SUBJECT: DONALD C. COOK NUCLEAR PLANT, UNITS 1 AND 2 – REVISED STAFF
ASSESSMENT OF RESPONSE TO 10 CFR 50.54(f) INFORMATION REQUEST
– FLOOD-CAUSING MECHANISM REEVALUATION (CAC NOS. MF6096 AND
MF6097)

Enclosure:
Revised Staff Assessment Related to the Flood
Hazard Reevaluation Report for D.C. Cook

STAFF ASSESSMENT BY THE OFFICE OF NUCLEAR REACTOR REGULATION

DONALD C. COOK NUCLEAR PLANT, UNITS 1 AND 2

Figure 3.2-1 – D.C. Cook site critical monitoring locations selected for LIP flood analysis (from D.C. Cook FHRR, Figure 3-4 (IMP, 2015b))

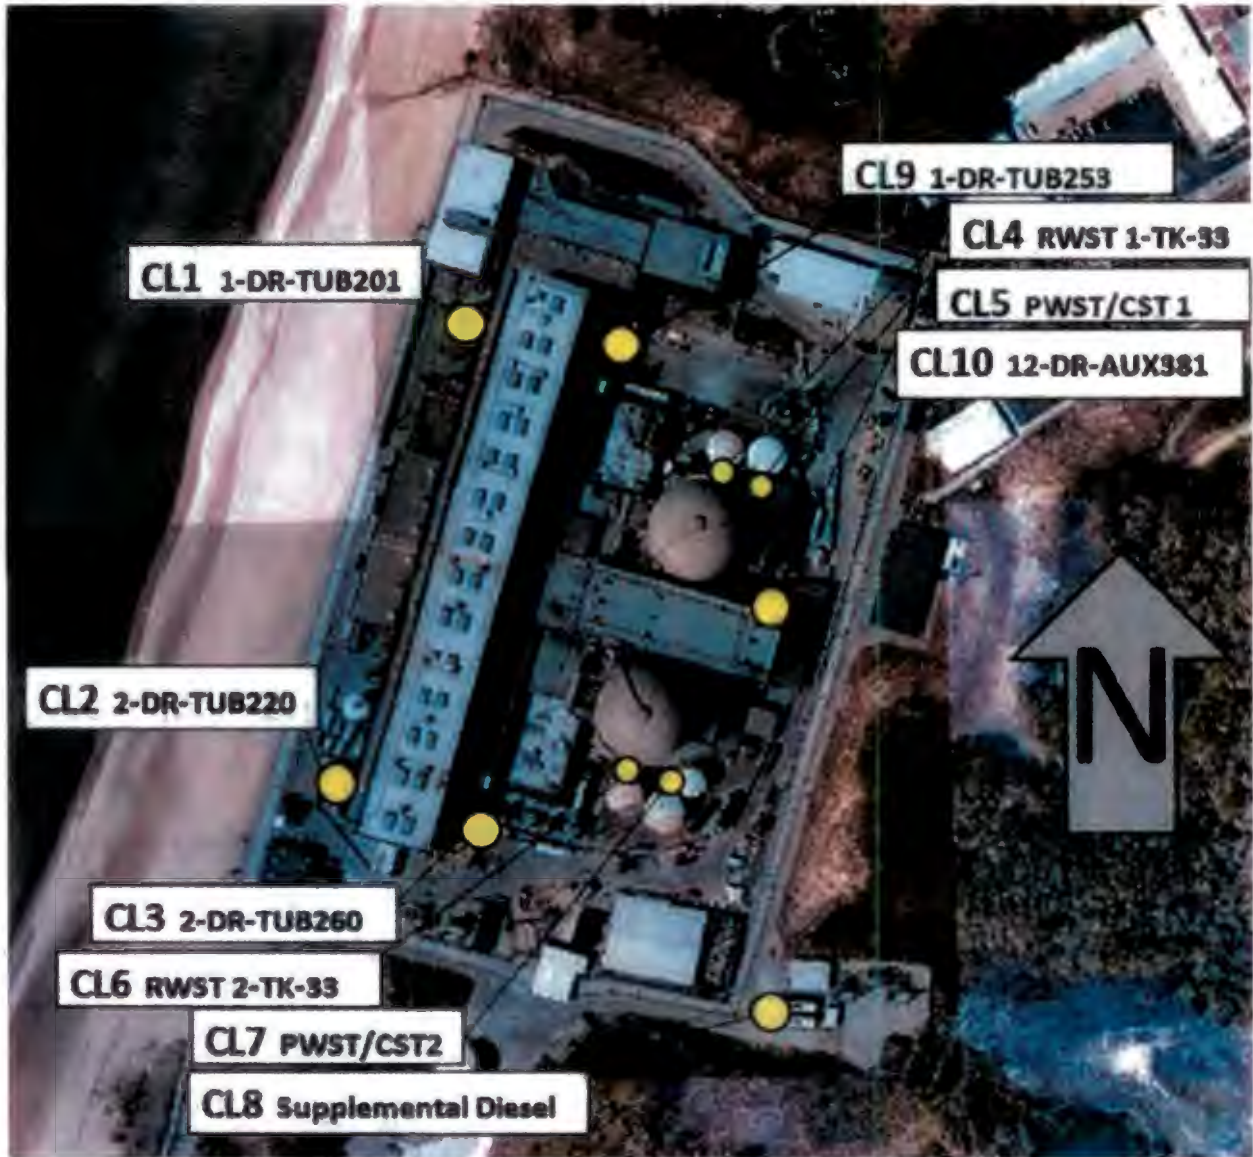
The licensee identified, based on general site and plant configuration and plant walkdown, 10 critical area locations where LIP runoff could impact SSCs important to safety of the plant as shown on Figure 3.2-1. These 10 locations are identified to be locations of potential SSC vulnerability where predicted flood elevations exceed surveyed threshold elevations and have the potential to produce adverse conditions. Additional realistic or conservative assumptions used in the LIP modeling are:

The NRC staff reviewed details of the licensee’s FLO-2D model implementation and determined that the approaches and assumptions were conservative and appropriate. The model output files reviewed by NRC staff did not report any errors related to model stability or mass balance. Based on a confirmatory run of the licensee-provided FLO-2D model, the NRC staff determined that the licensee’s conclusions, based on results produced by the model, are reasonable.
